Re: Record of Decision for the Fire Training Areas at the Seneca Army Depot Activity Superfund Site, Romulus, New York

**FINAL**  
**RECORD OF DECISION (ROD)**  
**THE FIRE TRAINING AND DEMONSTRATION**  
**PAD (SEAD 25) AND THE FIRE TRAINING PIT**  
**AND AREA (SEAD 26)**  
SENECA ARMY DEPOT ACTIVITY

## Response to Comments from the United States Environmental Protection Agency

**FIGURE 3-1  
LAND REUSE MAP**

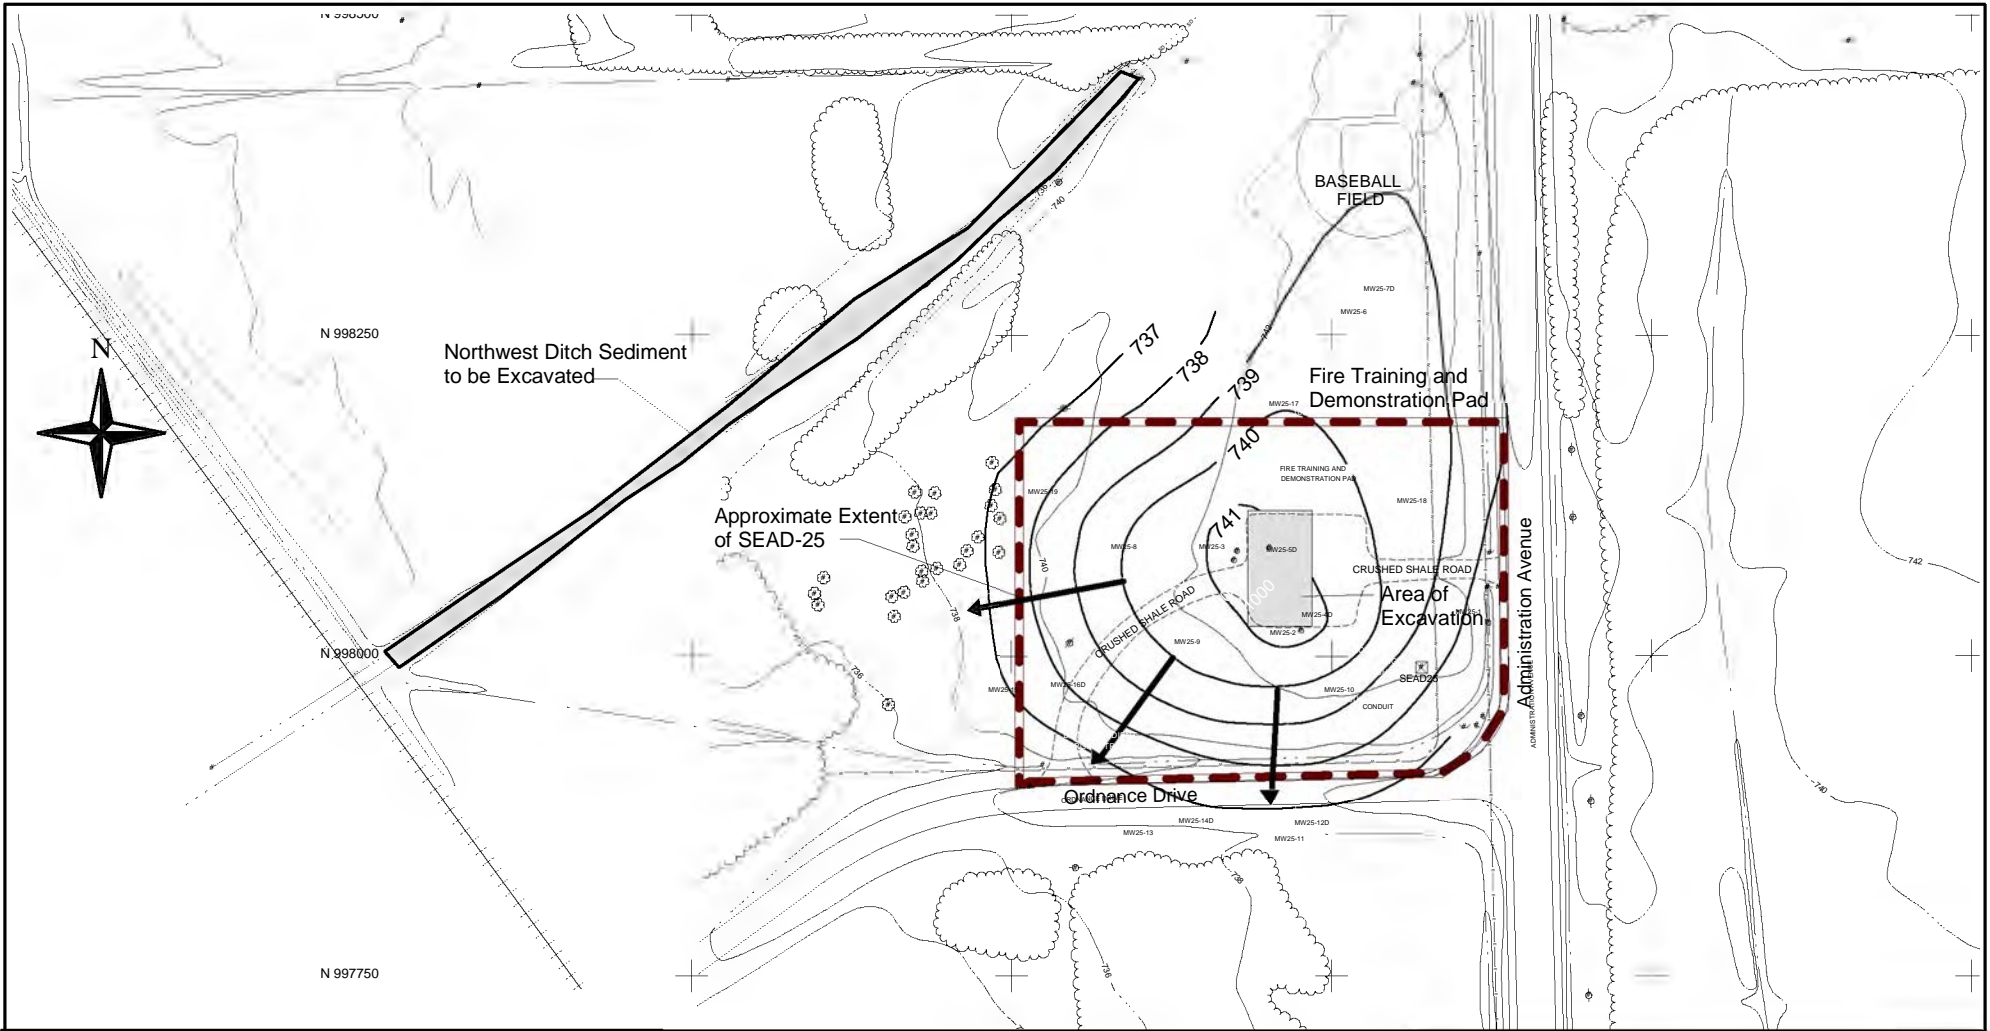
**Comment 50:** Figure 3-2: It would be helpful if this figure included the locations of SEADs 25 and 26.

**Response 50:** Assuming that the reference is to Figure 3-1, agreed. The location of SEAD-25/26 has been indicated on the map.

**Figure 6-2**  
SEAD-25 Areas to be Remediated  
Showing VOC Plumes in Groundwater

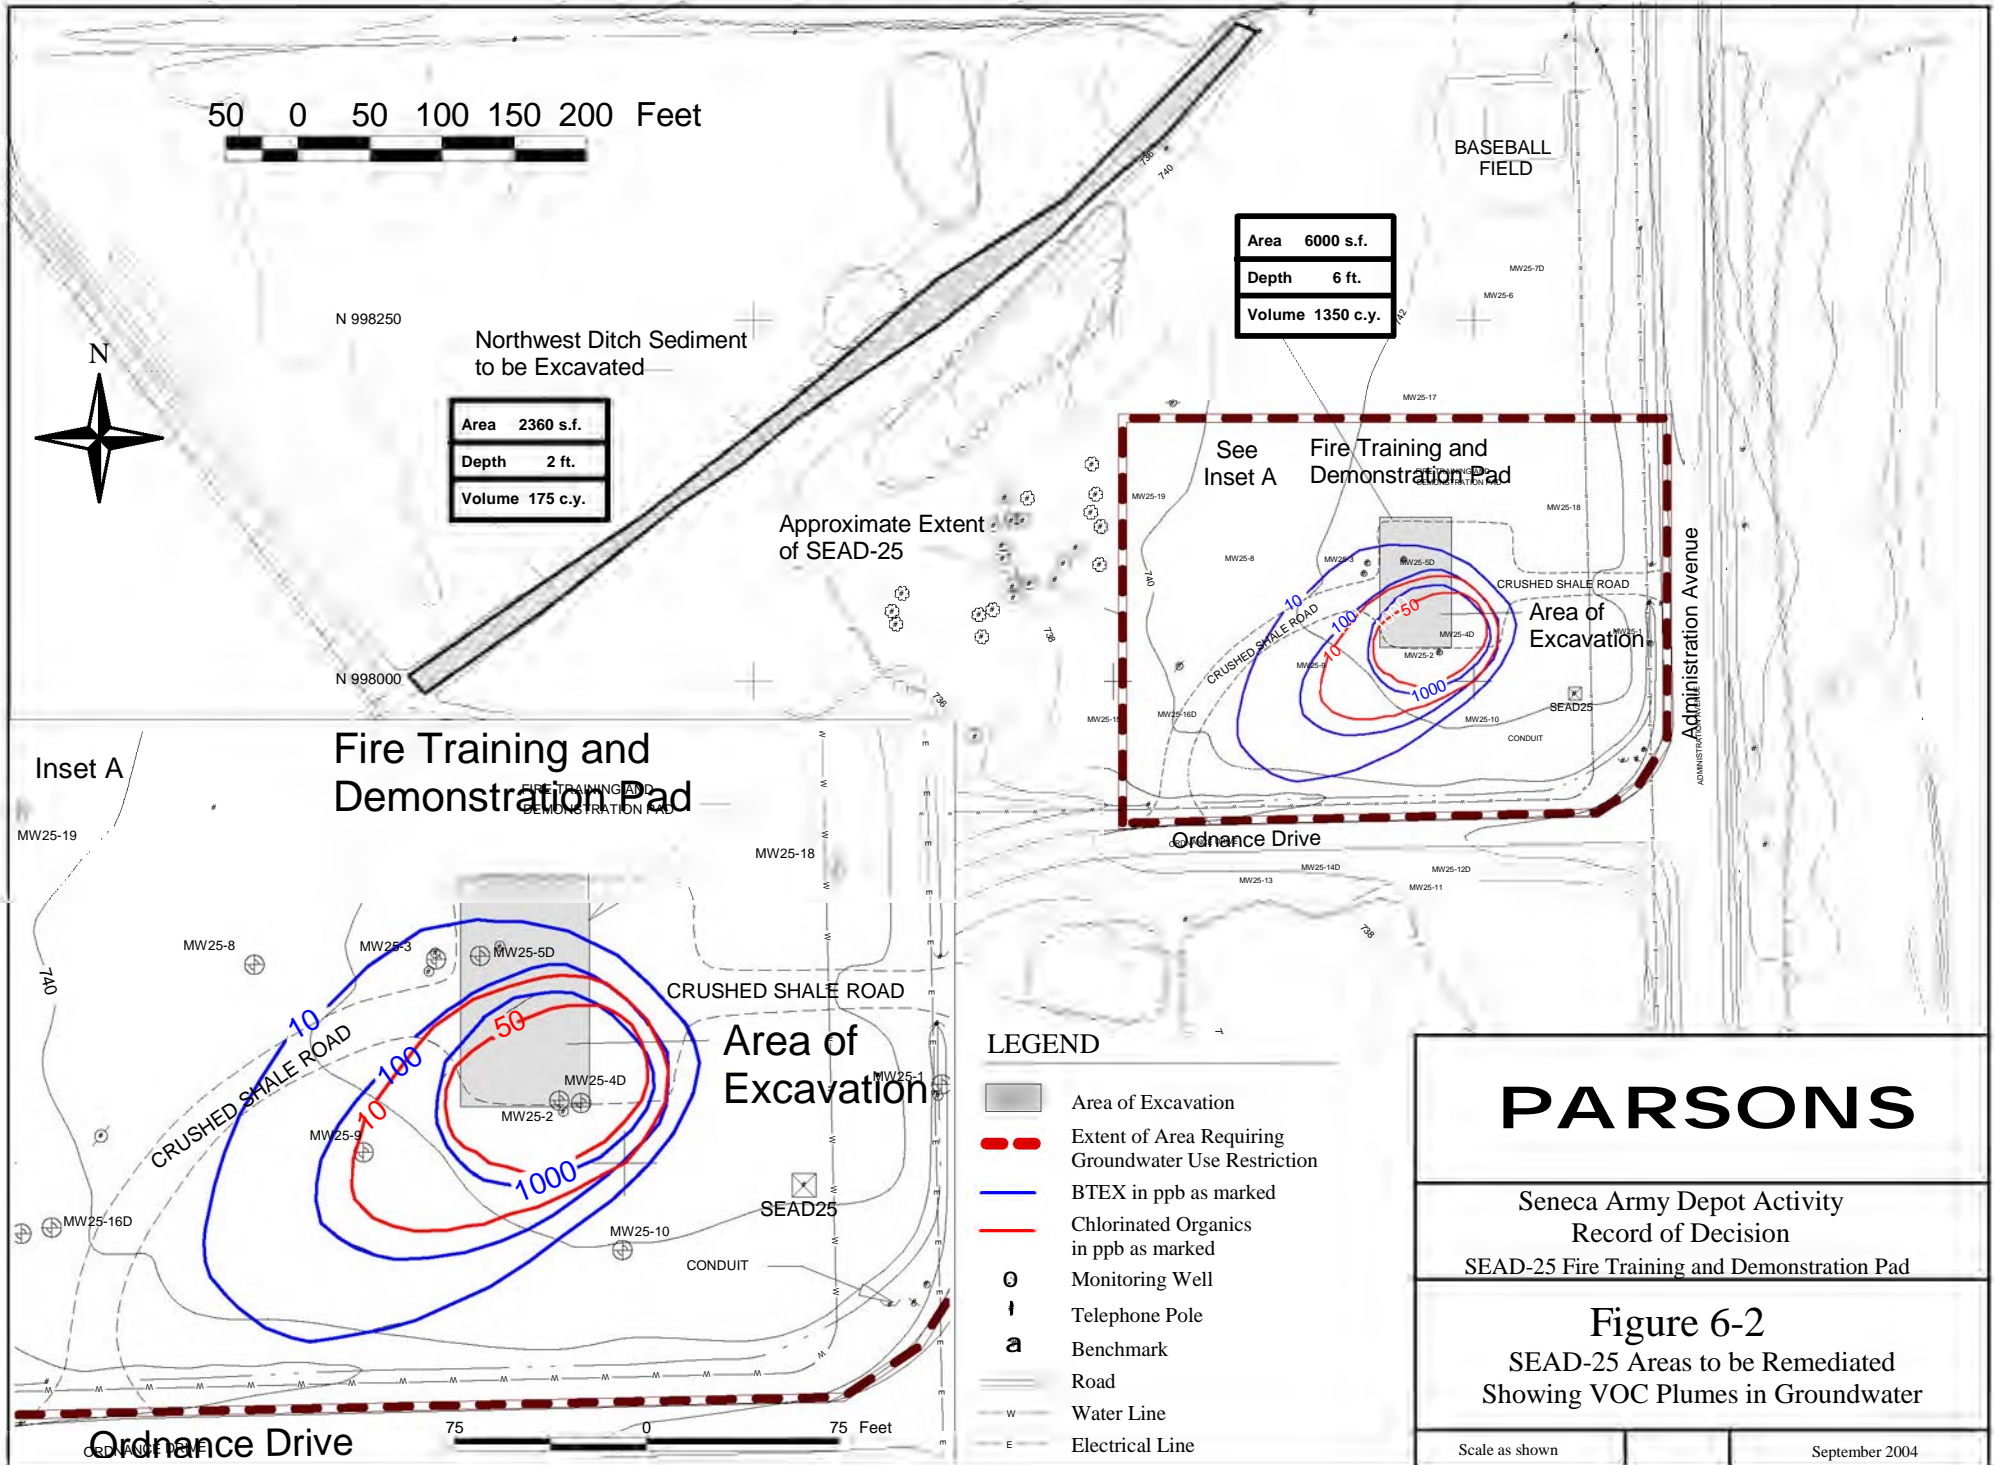
**Comment 49:** Figure 6-1: The groundwater flow direction in this figure does not correlate well with the plume sketches on Figure 6-2.

**Response 3:** Agreed. The areas requiring groundwater use restrictions without proper treatment until ARARs are achieved have been delineated on Figures 6-2 and 11-1 for SEAD-25 and SEAD-26, respectively. The concentrations in the outermost wells within the defined area comply with groundwater ARARs.

“(E)xcavate soil at the source in an area approximately 60 feet by 100 feet to a depth of 6 feet, as depicted in Figure 6-2, (approximately 1,350 cubic yards (CY).” The second bulleted item should read “(E)xcavate a volume of sediment approximately 780 feet long, 3 feet wide, and 2 feet deep, as depicted in Figure 6-2, (approximately 175 CY) from the northwest ditch.” Also, an additional bullet should be added to the elements of the remedy that states that the excavated soils will be disposed of at an off-site facility legally allowed to handle such wastes.
